SAFETY EVALUATION REPORT

Docket No. 71-9302
Model No. NUHOMS[®]-MP197 Transportation Package
Certificate of Compliance No. 9302
Revision No. 0

Figure 3.1 MP-197 Cask Body ANSYS® Model

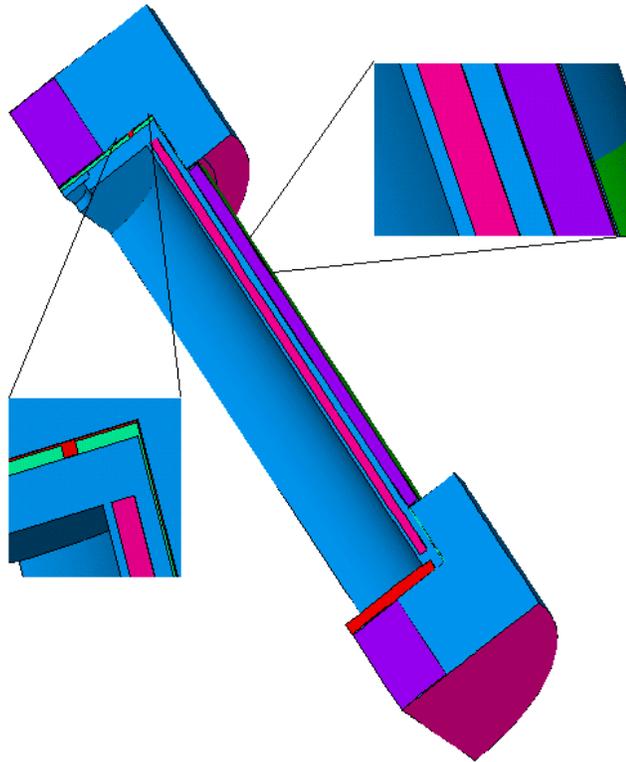
Redwood and balsa within the impact limiters are modeled as an isotropic material with material properties as described in Section 3.2 of the SAR. Figure 3.1 shows the cask body finite element model.

Figure 3.2 Canister and Fuel Basket ANSYS Model

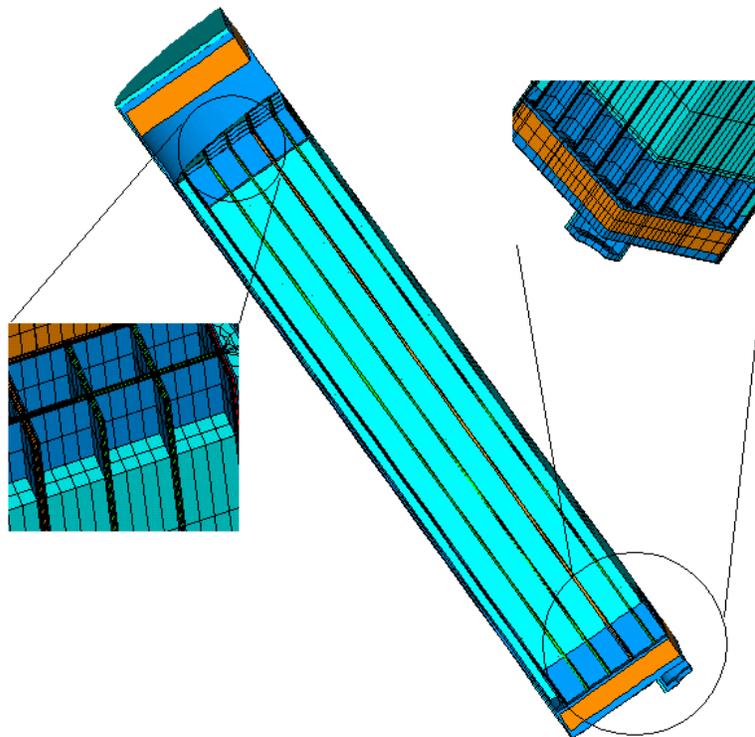
This model also includes fuel assemblies modeled as solid rectangular regions with an effective conductivity. The decay heat of the fuel was applied directly to the fuel elements and included a peaking factor of 1.2. As with the cask model, all gaps specified in the basket model are documented in the SAR. Figure 3.2 shows the fuel basket finite element model.

The applicant's approach to modeling the canister excluded all heat transfer mechanisms between the top of the fuel and the upper lid of the canister. While conservative for determining peak fuel cladding temperatures, the staff did not consider this a conservative approach for determining the maximum temperature of the cask seals. The applicant revised their thermal model to account for radiation in the gap between the top and bottom of the basket and the shield plugs of the canister. The revised analysis is presented in Appendix 3.7.5 to the SAR.

The applicant revised their thermal models to include conduction paths and to account for radiation in the gap between the top and bottom of the basket and the shield plugs of the canister. The applicant also used a value of 0.5 for stainless steel emissivity. In addition, the applicant chose to lower the absorptivity value of the stainless steel external cask surface to match a credible published value of 0.5. While this is less conservative than in the original analysis, the lower absorptivity value for stainless steel is considered to be realistic and is therefore, acceptable. The applicant determined that there was a maximum 14°F increase in seal temperatures. The maximum seal temperature according to the revised analysis was 231°F for normal conditions, which is below the seal temperature limit of 400°F. Given the margin between seal temperatures calculated for normal conditions and the seal temperature limits, the staff determined that it was not necessary for the applicant to re-analyze the seals for accident conditions. The staff reviewed the applicant's revised analysis and found that the analysis was acceptable.

Figure 3.4 MP-197 Bearing Block and Trunnion ANSYS® Models

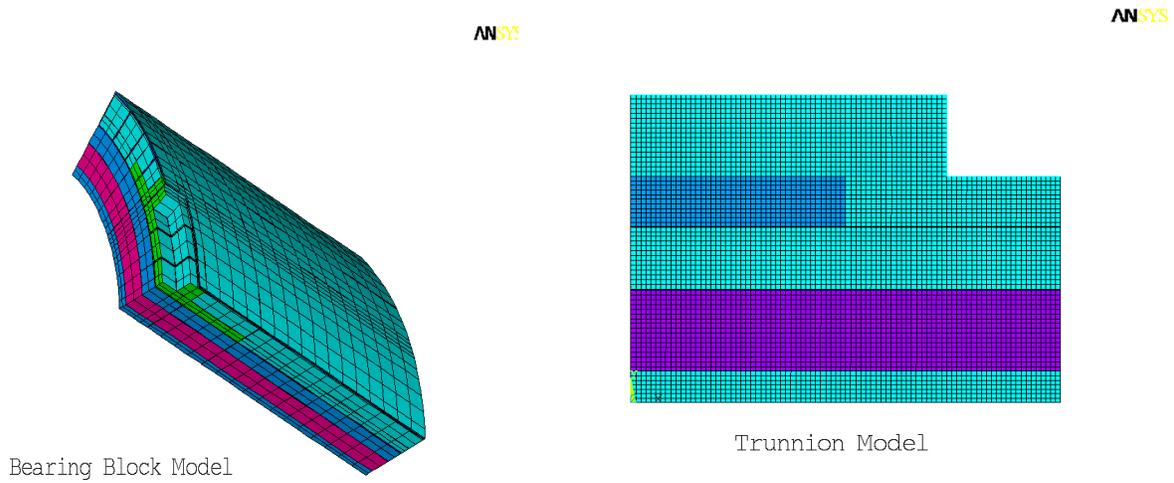
The applicant also developed a model of the cask bearing block to determine the peak transient lead temperature in the bearing block region. The model is a 3 dimensional quarter-symmetry finite element model that includes the geometry and material properties of the adjacent neutron shielding and the corresponding portion of the cask body. Gaps for this model are described in Section 3.5.5 of the SAR. The gaps in the model were removed for the fire transient, but were present for the pre- and post-fire transient. Both the Trunnion Region Model and the Bearing Block Model are depicted in Figure 3.4.
